Los Alamos National Laboratory

Review of the GMD Benchmark Event in TPL-007-1

September 2015

REVIEWER COMMENTS AND AUTHOR RESPONSE

Figure 2. PDF for independent peak geo-electric field magnitude observations for a subset of the IMAGE magnetometer stations. The solid lines are the extrapolations using power law fits to the extreme events.

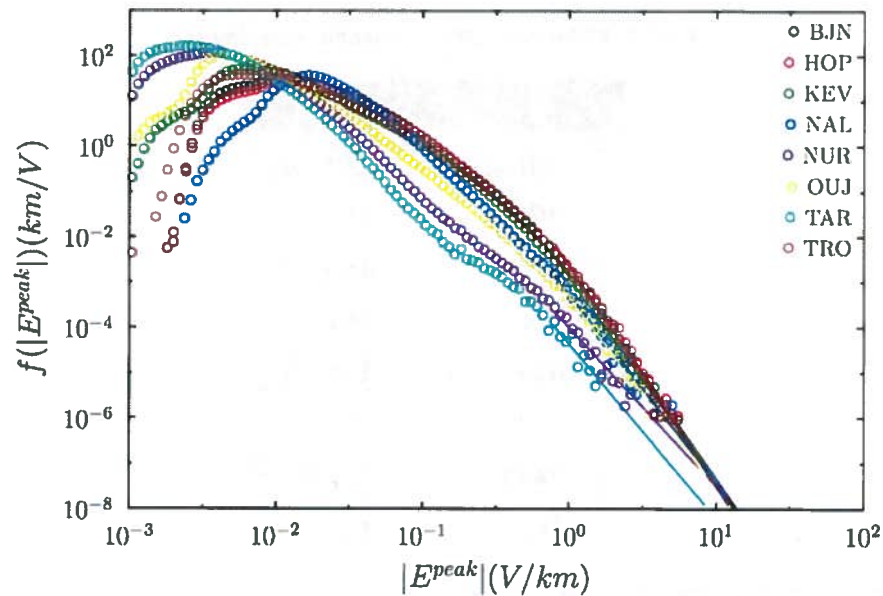
4. *Did you consider parametric forms for the distributions in Figure 2? If something fit well, you wouldn't need to extrapolate and the integral would be easier.*

9. Page 5: What power laws did you use? Not sure how they show a long tail but I may be misunderstanding Figure 2. It would be good to give a bit more detail here on how you do this.

Backhaus/Rivera: Based on our observations of the latitude scaling (and confirmation of this by Reviewer #1), we expect there to be a smooth transition in the tail behavior dependent on the latitude of the sensor. The transition is caused by the relocation of the electrojets as a function of the magnitude of the event. This cannot be represented by a simple parametric form for the distributions in Figure 2. Rather, we believe, as is pointed out in the discussion by Reviewer #1, point #2, that these distributions will ultimately be better represented by the combination of a statistical characterization of the magnitude of the event combined with a physical model of the impact of that event (i.e., the geo-electric field) on the ground. Until we can complete this work,

we believe the power-law extrapolation over less than one order of magnitude is an appropriate approach.

Backhaus/Rivera: We did not try a discrete set of power laws. The power law was a best fit power law decay to the tail of the distribution function. We did not consider other canonical forms.

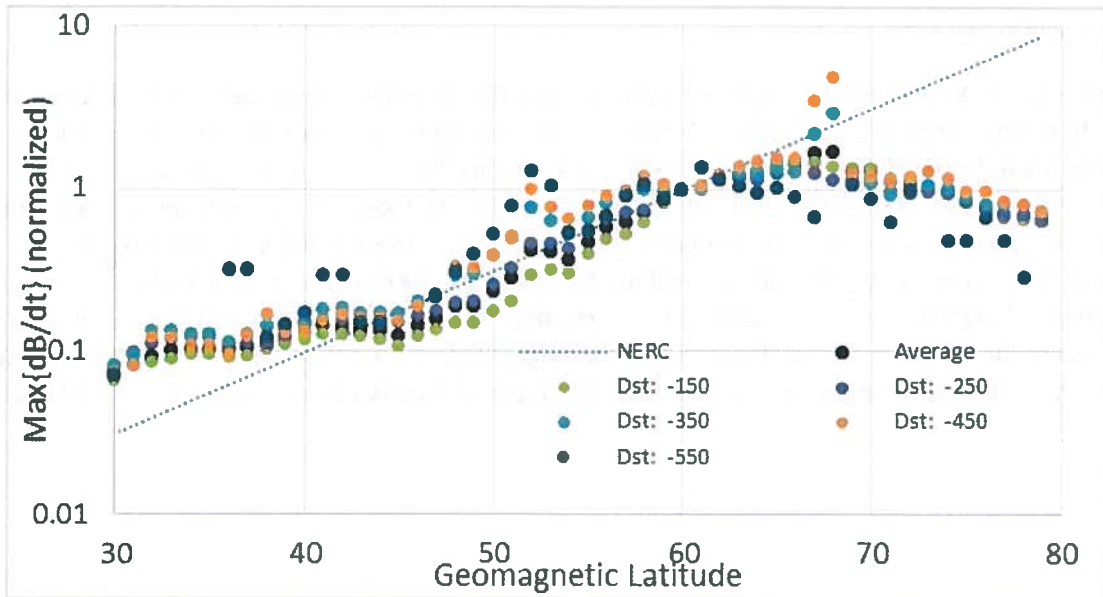
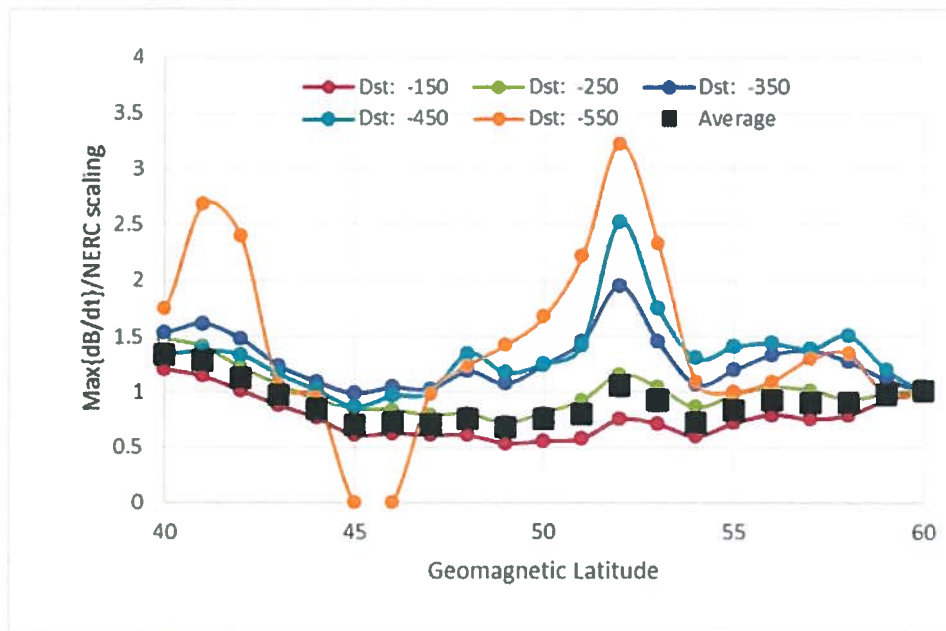
2. Regarding the latitude scaling and use of Dst: For the latitudes you consider, Dst may not be the best index. It represents the ring current, while the magnetic disturbances at high latitudes are due to the electrojets, which are more related to the Auroral Electrojet (AE) index. While Dst and AE are also correlated to some degree, using AE may give you a cleaner signature in Figs 4 and 5.

Backhaus/Rivera: We agree. We have done a preliminary analysis using AE index, as well as the Kyoto Sym-H index, however, we have not yet completed this work. Once complete, we will include it in subsequent journal papers. However, our preliminary analysis shows that no change is expected in the analysis results presented in the report. For the large events that contribute to the Dst<-400 plot in Figure 5, AE and Dst are sufficiently correlated that AE selects the same subset of events as Dst. The plot in Figure 5 will remain the same.

Figure 4. USGS earth layer resistivity data for the Cascade Sierra region

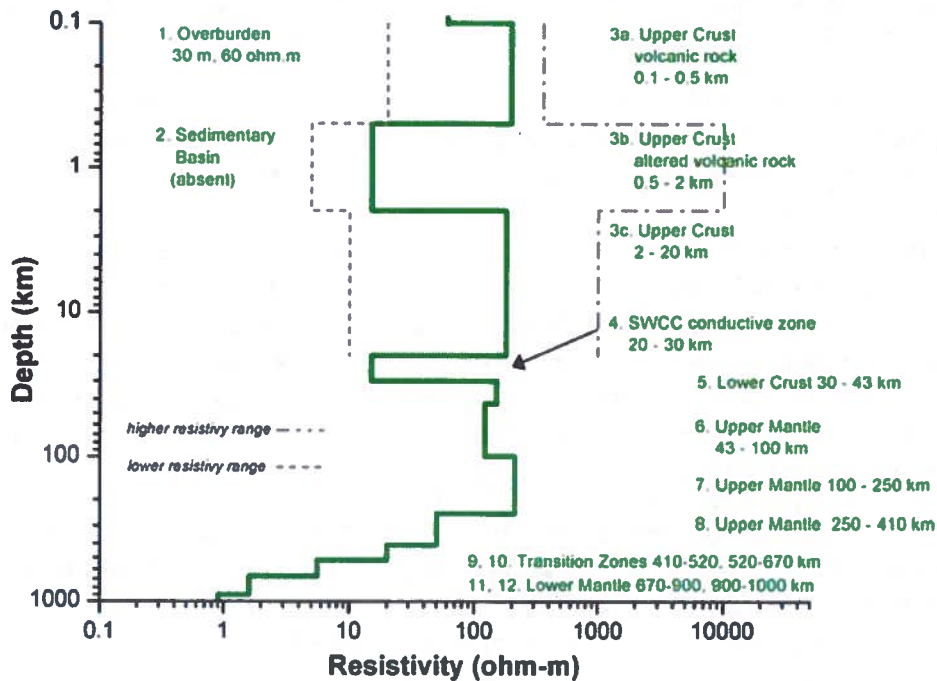
8. *In considering the uncertainty in earth conductivity data, Figure 6 is for the Cascade Sierra region but the subsequent analysis is for a Florida region. Is it even important to mention that initial investigations used the Florida region*

Backhaus/Rivera: No, it is not. We did the same analysis for all the regions. The text is a holdover from a previous draft when a second figure showing the analysis for Florida was inserted. That figure was removed, but the text inexplicably remained. The text has been removed.

Figure 5. Worst case (blue bars) and best case (grey bars) peak geo-electric field values for a subset of USGS regions that report uncertainty ranges in conductivity values. The orange bars are the values obtained using the USGS recommended value.

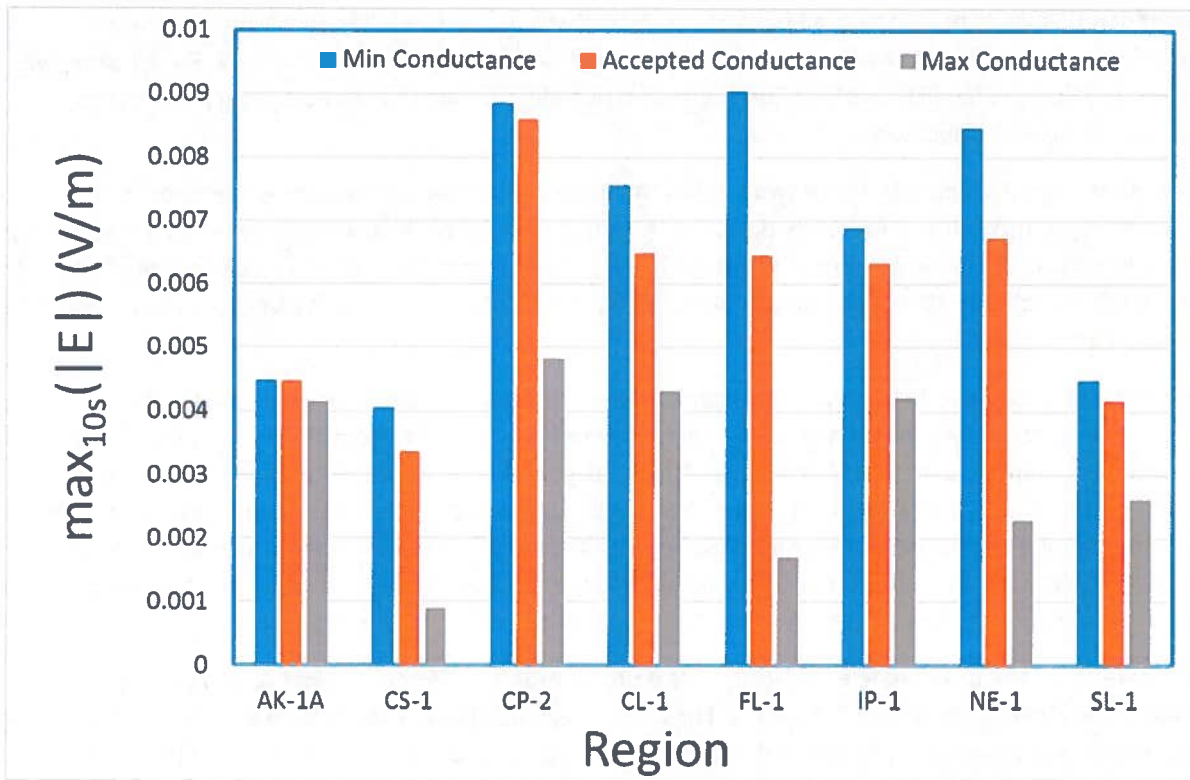
3. On the Sensitivity study on earth conductance - your approach is to vary the top 4 layers of the USGS model. It is the only bit I actually disagree with. For the frequency of fluctuations we’re dealing with, the work of Anti Pulkkinen showed that the layers that have the biggest effects are not near the top but rather exist in the 10-100km range of depth - so for your sensitivity study you should vary those layer’s resistivity range. This is kind of hinted at by your result - where up to three orders of magnitude resistivity variation in say the second layer results in only factors of 2-4 and often less variation in the induced field. That rather speaks to the induced electric field strength being rather insensitive to the variations of resistivity in the top layers. I suggest that this part of the work needs to be redone.

Backhaus/Rivera: We agree that the computed geo-electric field is more sensitive to uncertainty in the lower layers. However, the USGS data available to us report resistivity ranges only for the upper layers and not for the lower layers. The intent of this report is to discover and advise on the unresolved uncertainties within the TPL-007-1 screening process. If these uncertainties are overestimated without justification, the end result may be over-application of very expensive GMD mitigation measures on a nationwide basis. Therefore, we have chosen our current approach to avoid alarmism by only considering layers in the geological model where USGS provides ranges, even though those ranges are ill defined, with descriptive phrases like “possibly representative.”

Our conclusion is that more work needs to be done to generate better-defined Earth layer conductivity data sources for use in TPL-007-1. To address your concerns, we have added a

discussion of this matter indicating that the reported ranges in Figure 7 likely underestimate the true range when uncertainty in the resistivity of the lower layers is included.
